Technical Service Bulletin

40 Front shock absorber cap, cracking noises/spring jumps when steering

40 20 20 2047758/6 November 24, 2020. Supersedes Technical Service Bulletin Group 40 number 20-09 dated June 26, 2020 for reasons listed below.

Model(s)	Year	VIN Range	Vehicle-Specific Equipment
A3, S3	2015 - 2021	All	Drive select and magnetic shock absorbers

Figure 1. Shock absorber and buffer stop.

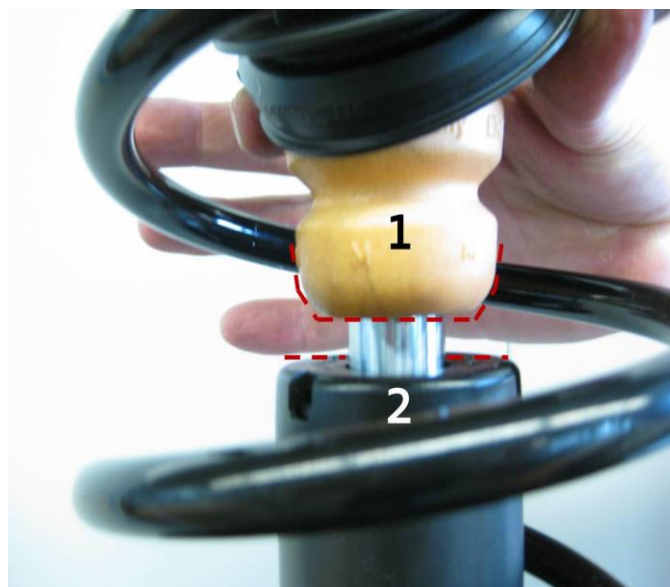
The buffer stop for the shock absorber (Figure 1, 1) can cause noises if it touches the front shock absorber cap (Figure 1, 2).

Lightly lubricate the contact surface (red dotted line) between buffer stop for shock absorber (Figure 1, 1) and front shock absorber cap (Figure 1, 2) with 5 grams of silicon grease G 000 405 A2 per side.
